ADDENDUM NO. 2

BUNCOMBE COUNTY SCHOOLS ERWIN HIGH SCHOOL E-WING ROOF REPLACEMENT ASHEVILLE, NORTH CAROLINA

Erwin High School E-Wing Roof Replacement Buncombe County Public Schools February 27, 2012 – Addendum No. 2

BULLETIN DRAWING NO. 1 BUNCOMBE COUNTY SCHOOLS ERWIN HIGH SCHOOL E WING ROOF REPLACEMENT

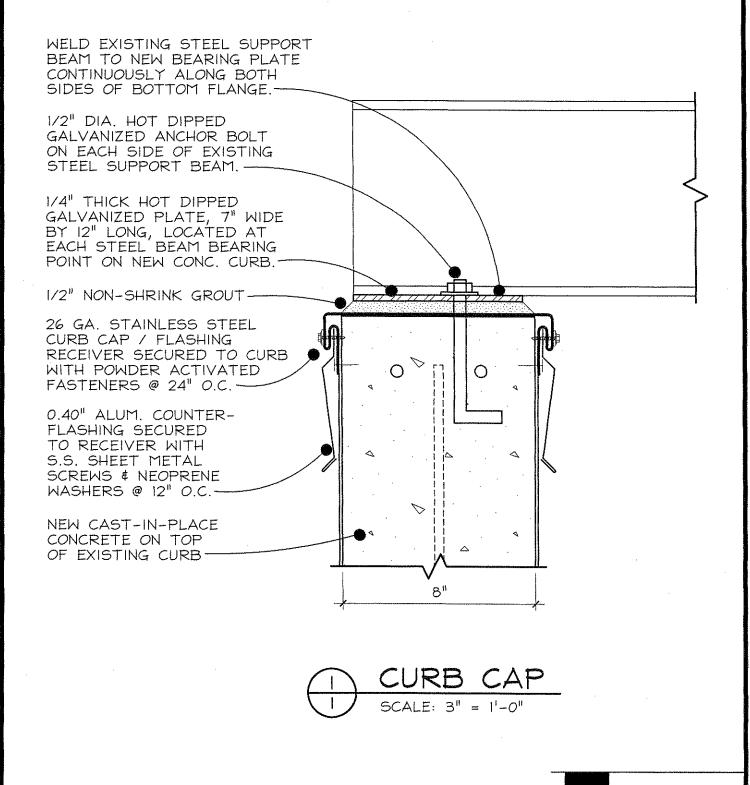
- Item 6: Refer to the Specifications Division 7 *Thermoplastic Polyolefin (TPO) Roofing.*Page 0753-8, Article 2.3. Revise Paragraph A as follows:
 - A. For concrete roof deck one ply of base sheet vapor barrier/temporary roof: ASTM D6164, Grade S, Type I, 90 lb/sq, 180 b/m² polyester reinforced, SBS modified asphalt sheet, smooth surface set in bitumen-based cold adhesive to primed cast-in-place concrete roof deck. Heat-weld all seams. Observe Manufacturer's Requirements for moisture content of substrate.
- Item 7: Refer to the Specifications Division 7 *Thermoplastic Polyolefin (TPO) Roofing.*Page 0753-8, Article 2.4. Revise Paragraphs B and C to change compressive strength of polyisocyanurate board and tapered insulation from 25 psi to 20 psi
- Item 8: Refer to <u>attached</u> Bulletin Drawing No. 1 for attachment of existing steel beam to the top of the raised concrete curb.
